NLC INDIA LIMITED

**Sub:** Hon'ble Commission's Approach Paper on determining terms and conditions of Tariff Regulation 2024-29- Remarks from NLCIL – Reg

NLCIL's Comment on Approach Paper on determining Terms and Condition of Tariff Regulations - 2024-29

Figure 1: Furnace Fouling Sketch

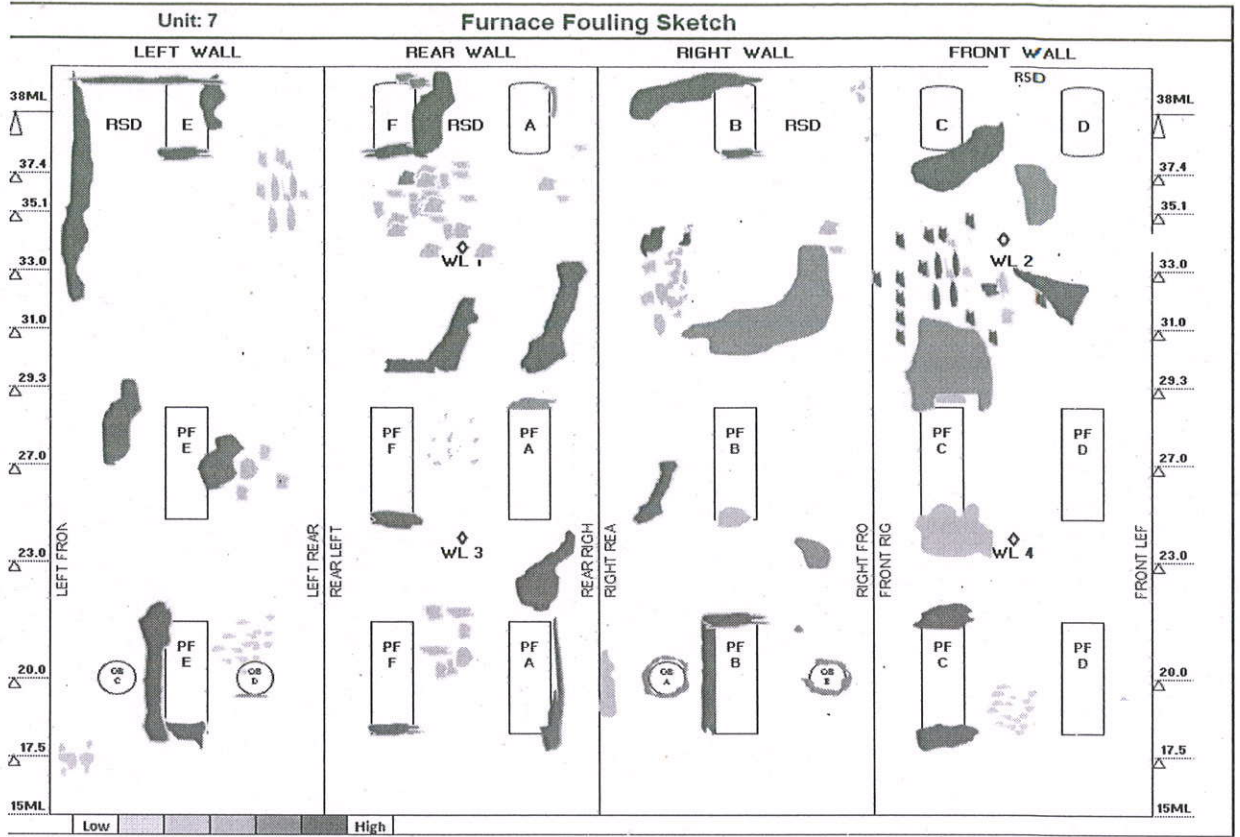
- l) Slagging of furnace walls is a typical phenomena and it is very high in NLCIL lignite fired boilers (figure 1). Slagging affects heat transfer, high exit flue gas temperature, poor boiler efficiency, over heating of coils, etc.

- m) For slag removal, Water lance operation unique for only Lignite Fired Boilers is very much required. At low loads, heavy fluctuations develop in the furnace if water lances are taken into service, leading to furnace instability (figure 2) as water quenches the fire ball and eventually resulting in tripping of the Unit.
